ADDENDUM NO. 2

Date of Issue: February 14, 2024

To all prospective bidders of record on the Work titled: **Biosolids Handling Facilities and Odor Control Improvements**

LAGOON DECOMMISSIONING PLAN - II

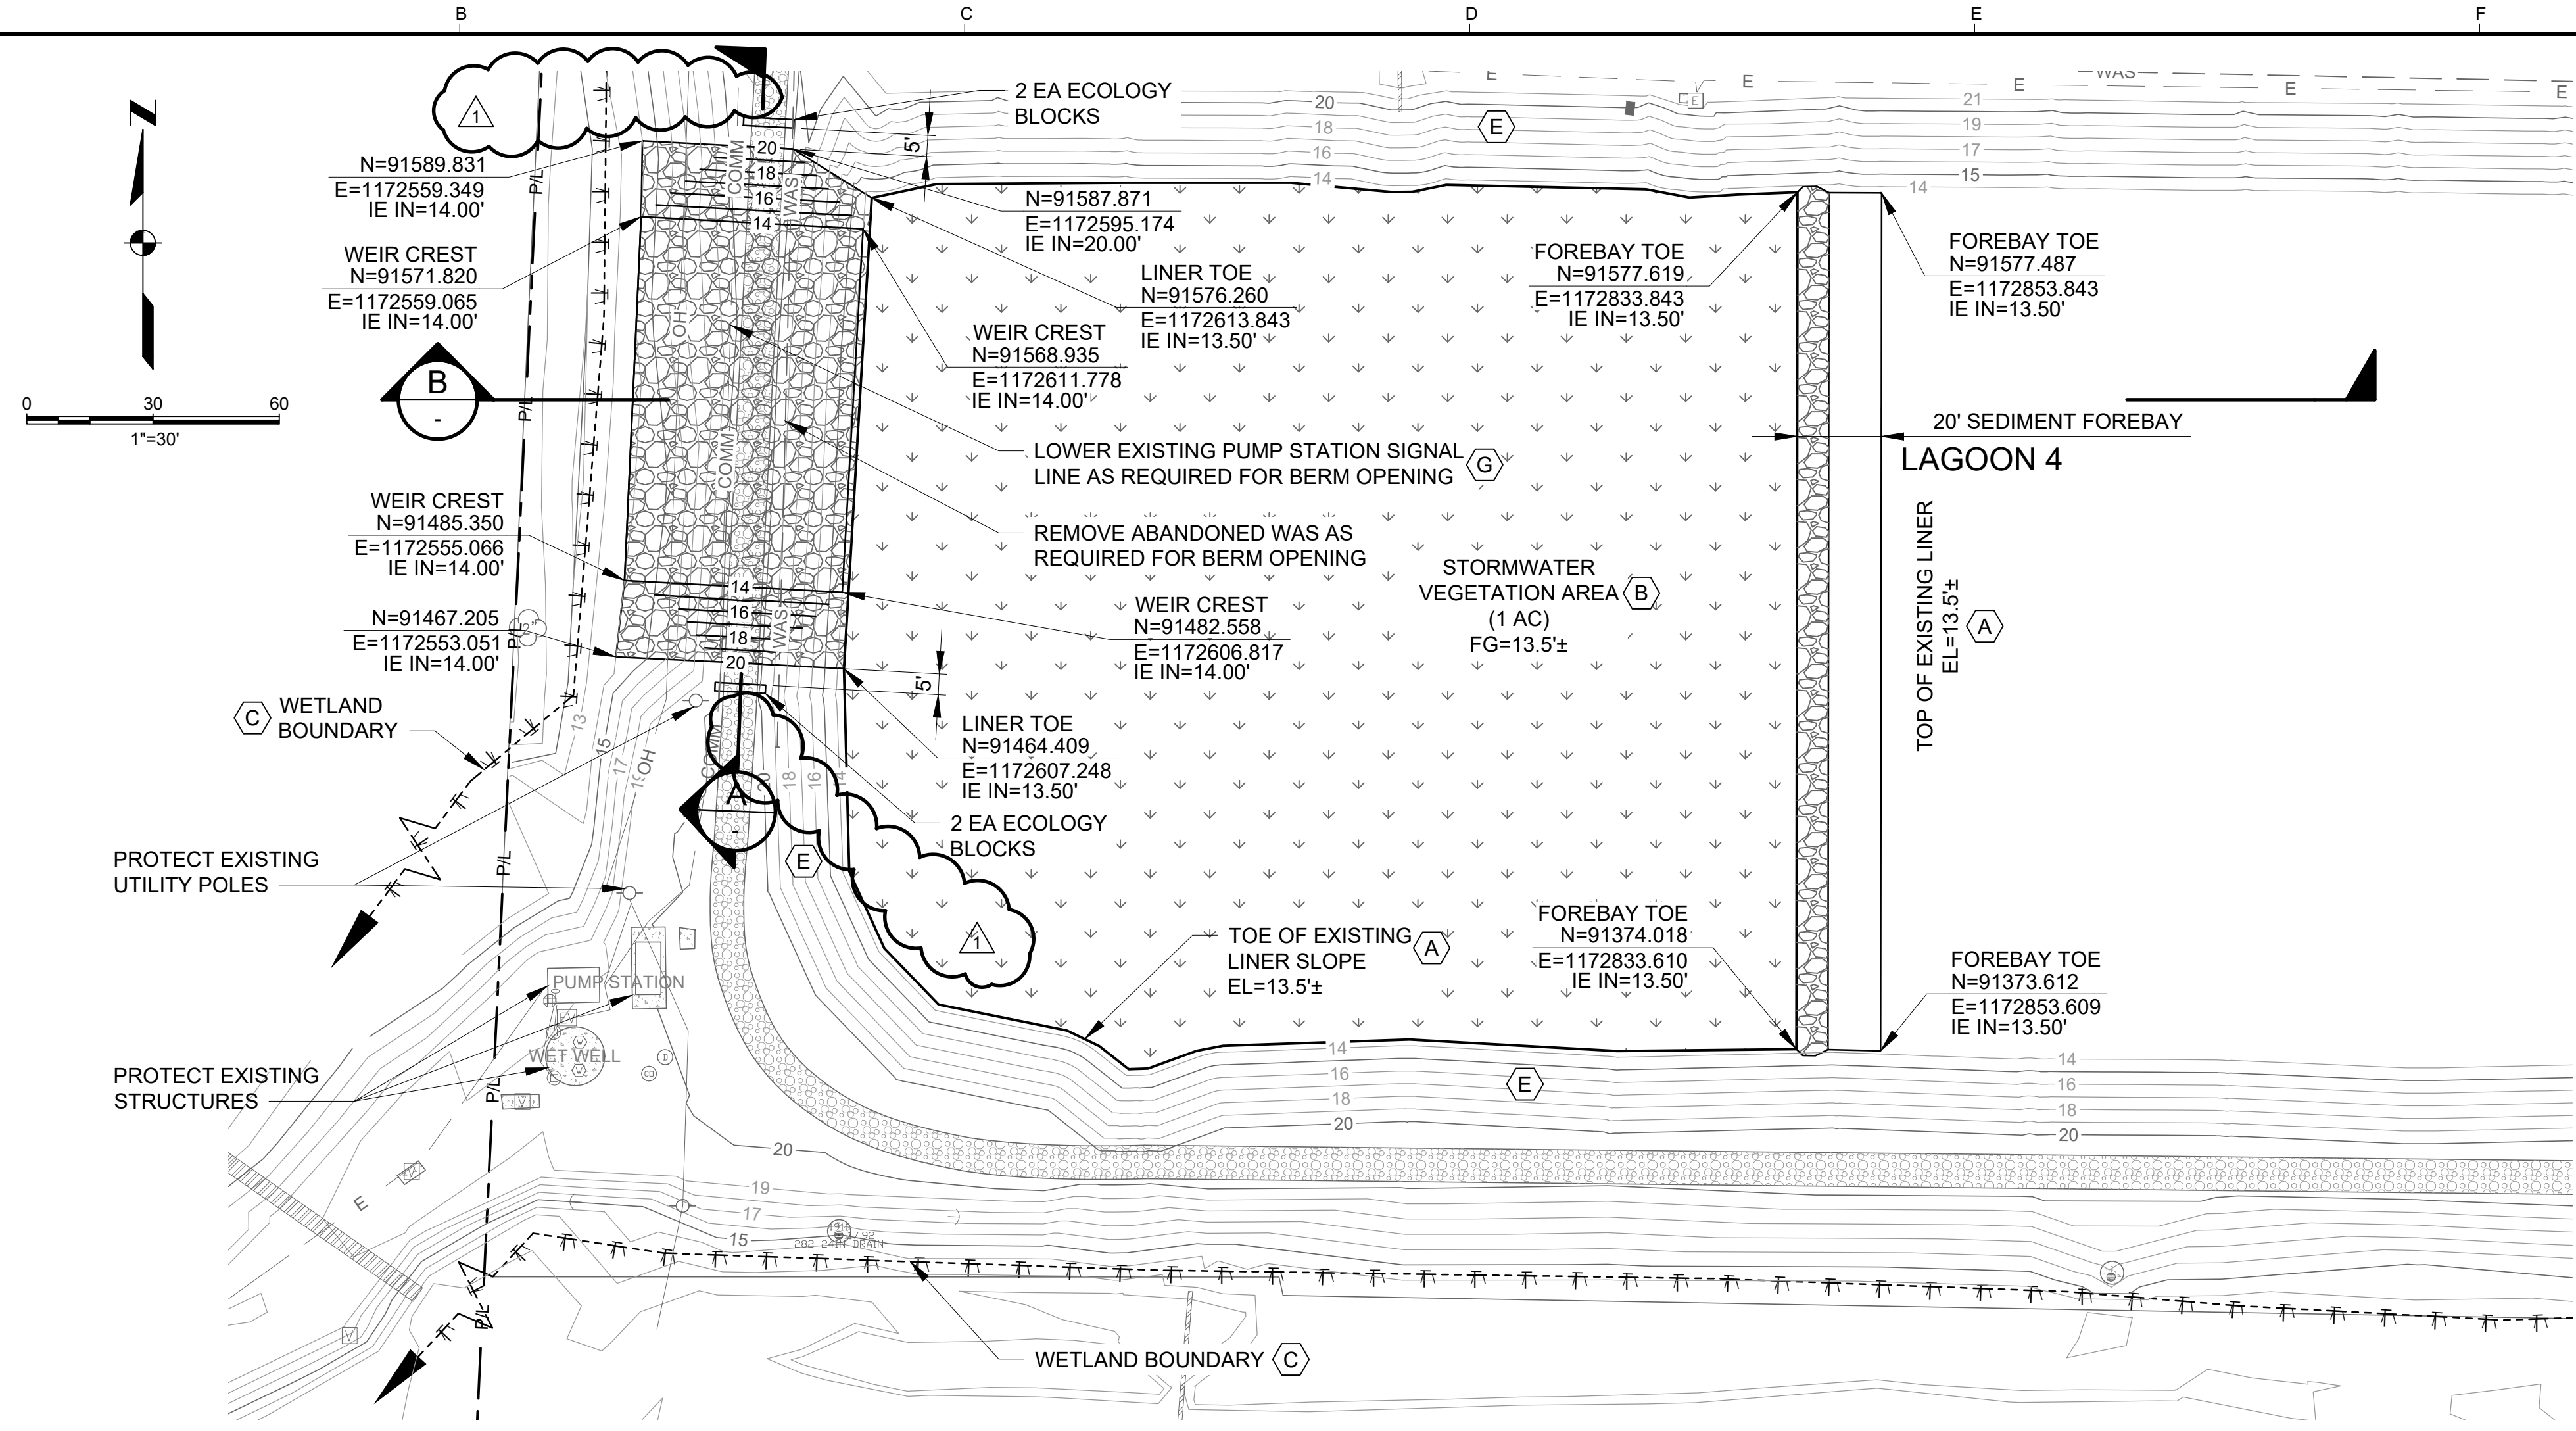
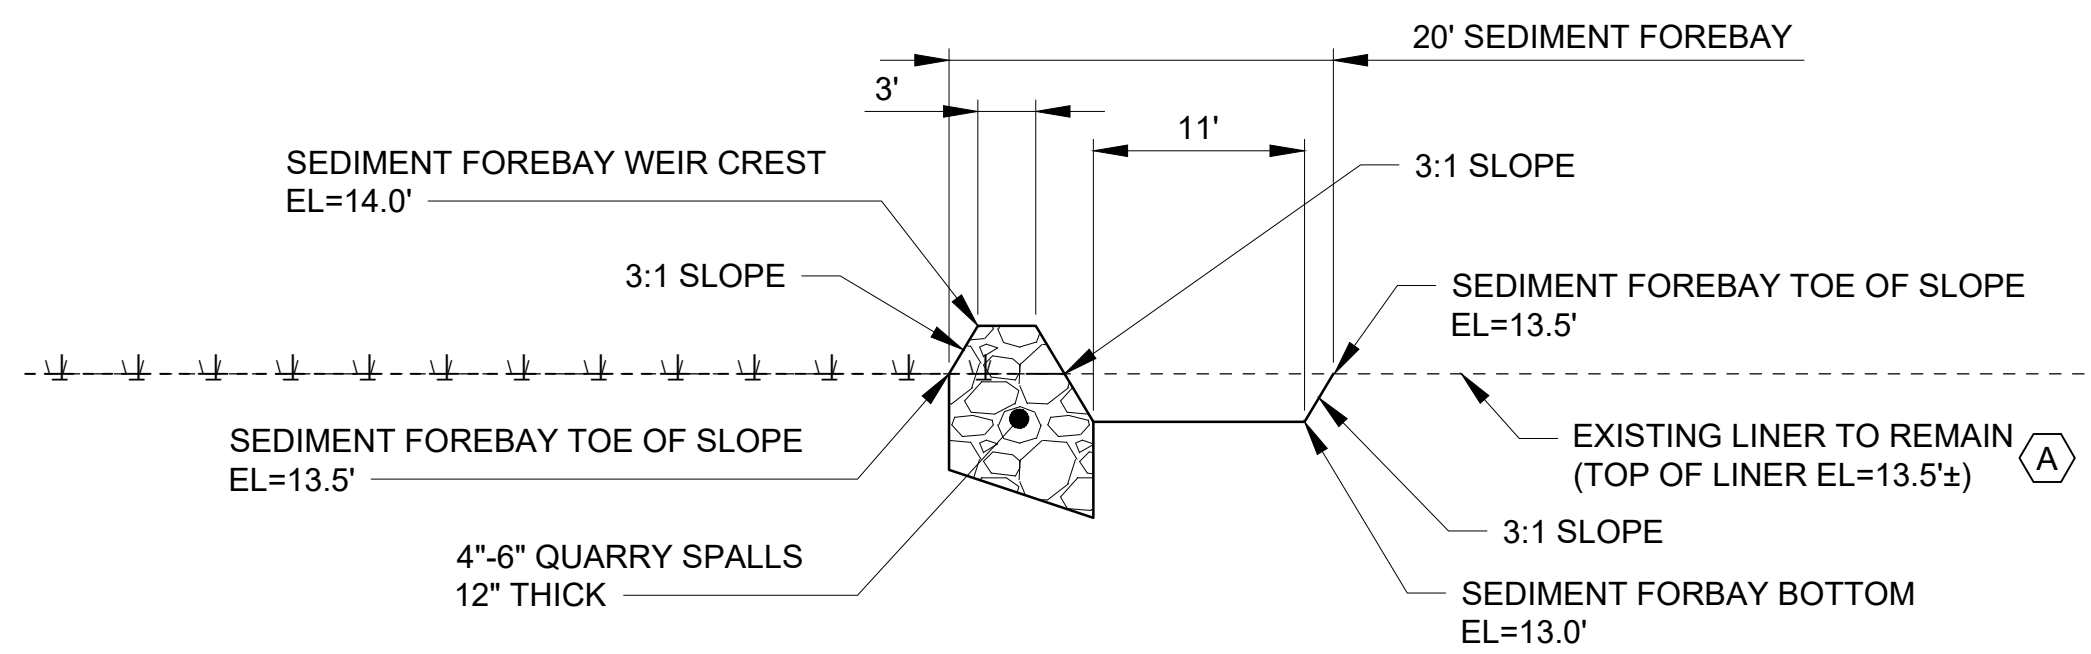
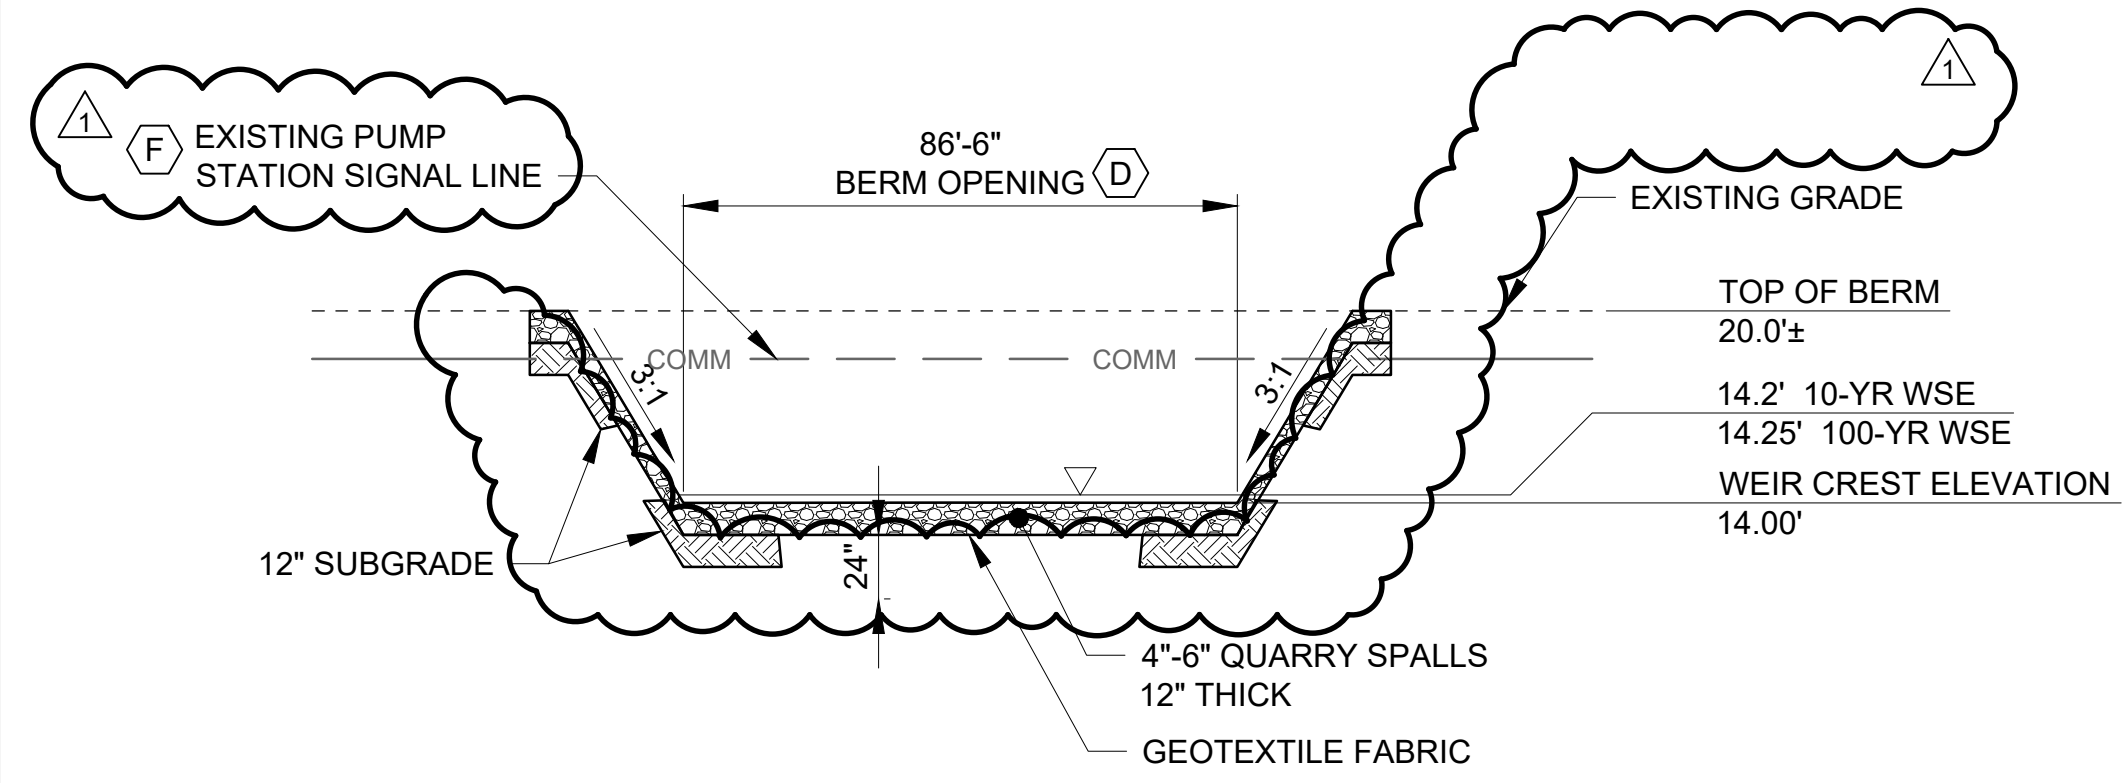
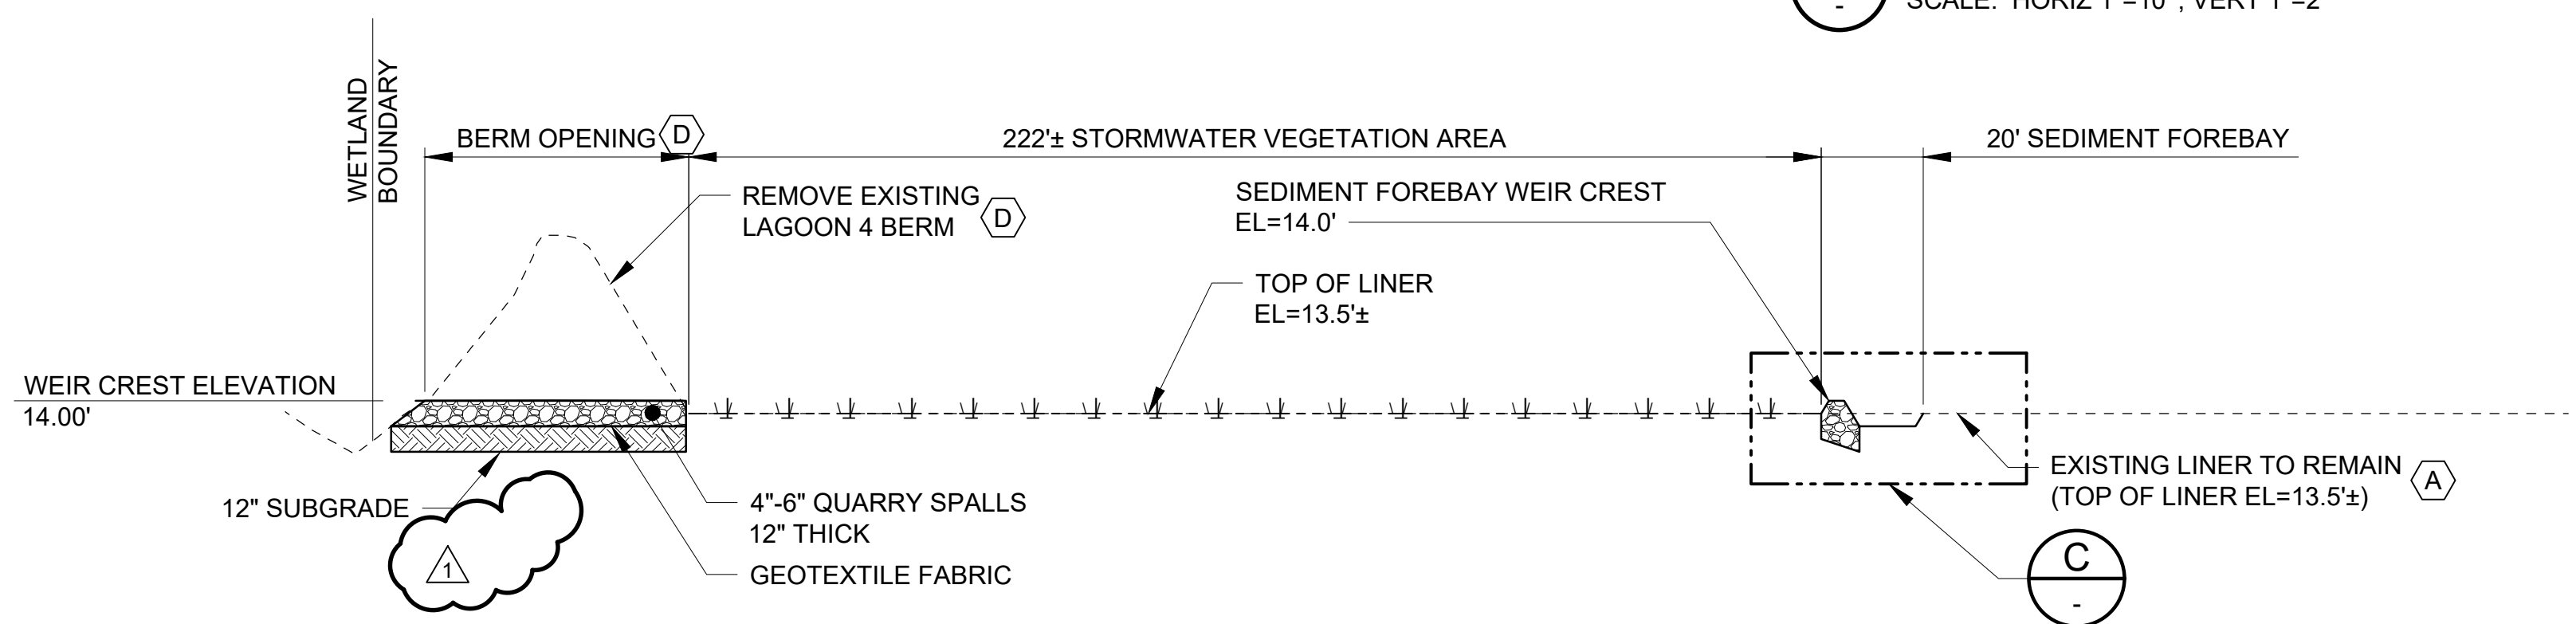
- Item AD2-4 Sheet D-004 LAGOON DECOMMISSIONING PLAN - II
- Replace Sheet D-004 LAGOON DECOMMISSIONING PLAN – II in its entirety with the revised Sheet D-004 LAGOON DECOMMISSIONING PLAN – II attached to this addendum. Changes are noted on the drawing.
